Sediment Basin Design Guidance Revisions

Jordan A. Basham, PE
Louisville MSD
(502) 540-6634
jordan.basham@louisvillemsd.org

EXHIBIT 12-8B
TEMPORARY SEDIMENT BASIN

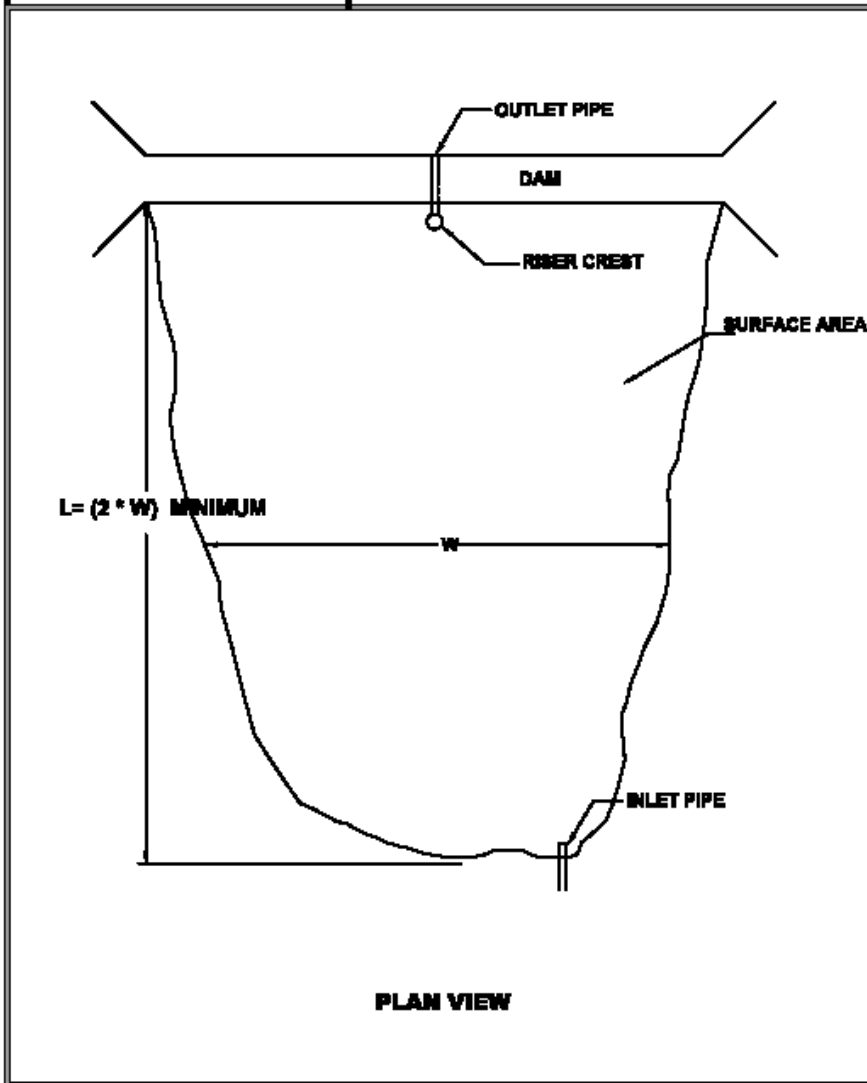
Current Detail

- Require Preliminary EPSC plan (PEPSC) prior to full construction approval
- Require side slope stabilization on construction detail
- Eliminate low flow orifice as dewatering mechanism; replace with skimmer
- Transition sediment basin design guidance from Exhibit to Standard Drawing

Louisville and Jefferson County Metropolitan Sewer District 700 W. Liberty Street Louisville, Kentucky 40203-1913 <small>502-587-0603 - WWW.LOUISVILLEMSD.ORG</small>	
SEDIMENT BASIN - LAYOUT	
STANDARD DRAWING NO.	EB-03-01
APPROVED BY: _____	DATE _____
CHIEF ENGINEER

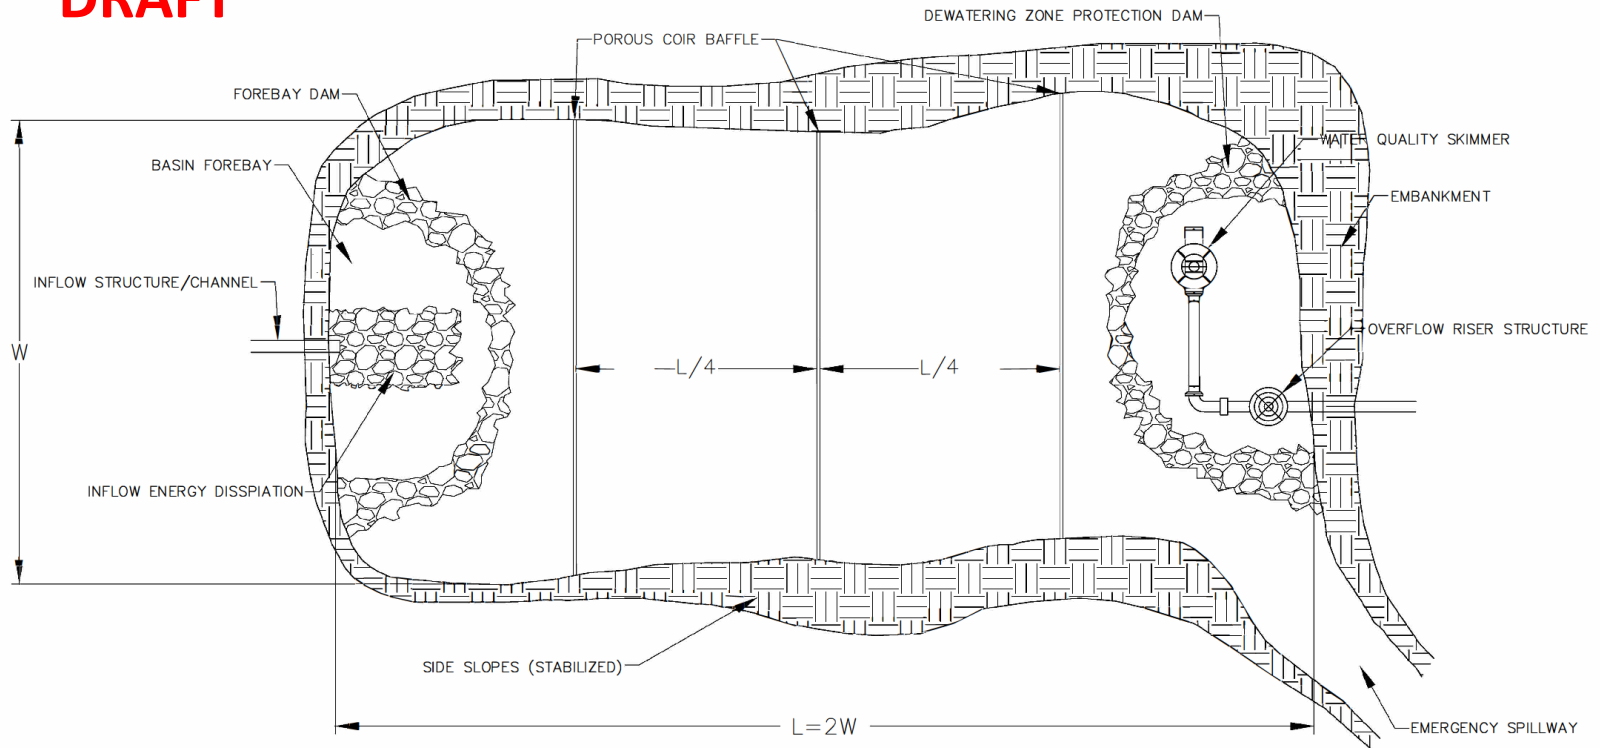
- Basins must still meet 80% TSS removal efficiency for 10-yr, 24-hr storm
- Outflow through three spillway devices:
 - Primary Riser (10-yr, 24-hr WSE at 6" max above riser)
 - Floating Skimmer (drain within 48 hrs)
 - Emergency Spillway (pass 100 yr, 24 hr storm)

1. For Sediment Storage Volume (SSV) calculations, refer to MSD Design Manual Exhibit 12.6.1.
2. The Forebay shall be sized to provide 20% of the basin's SSV.
3. Clean out marking stake should be installed to indicate when sediment storage capacity has been reached (SSV is being fully utilized); and clean out should occur when sediment level reaches 1/3rd of the full SSV elevation.
4. Side slopes should not be steeper than 3H:1V, and must be fully stabilized when basin is in service.
5. Anti-seep collars should be fitted on all penetrations through the embankment/dam.

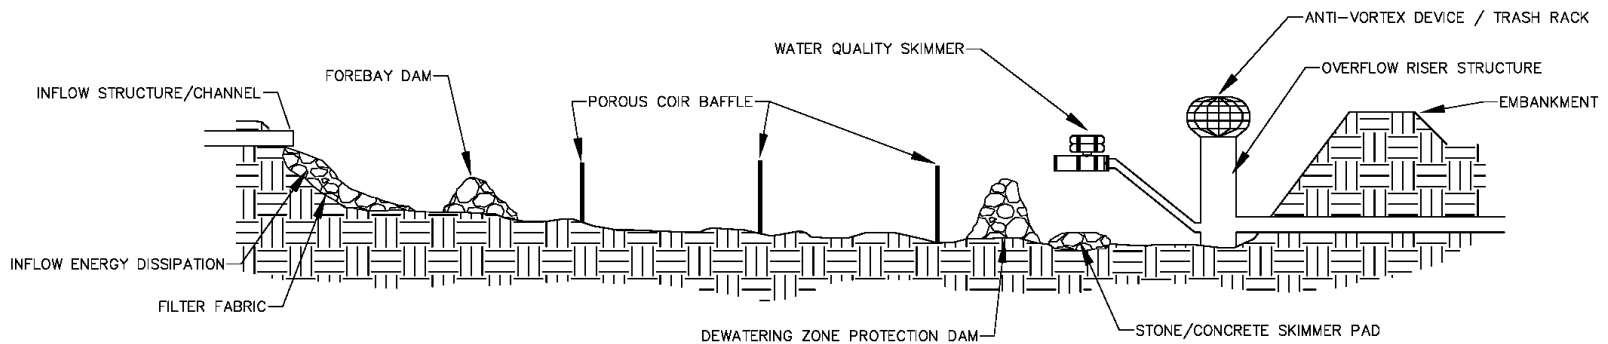
Proposed Standard Drawing - Section

1. Forebay and Dewatering Zone Protection Dams shall be a minimum of 1' high and shall have a top elevation of 1' above the SSV.
2. The 10-year, 24-hr storm elevation should be 6" above the crest of the overflow riser structure.
3. The crest of the emergency spillway should be located a minimum of 18" above the crest of the overflow riser structure.
4. The top of the embankment/dam should be located a minimum of 1' above the 100-yr, 24-hr storm elevation.
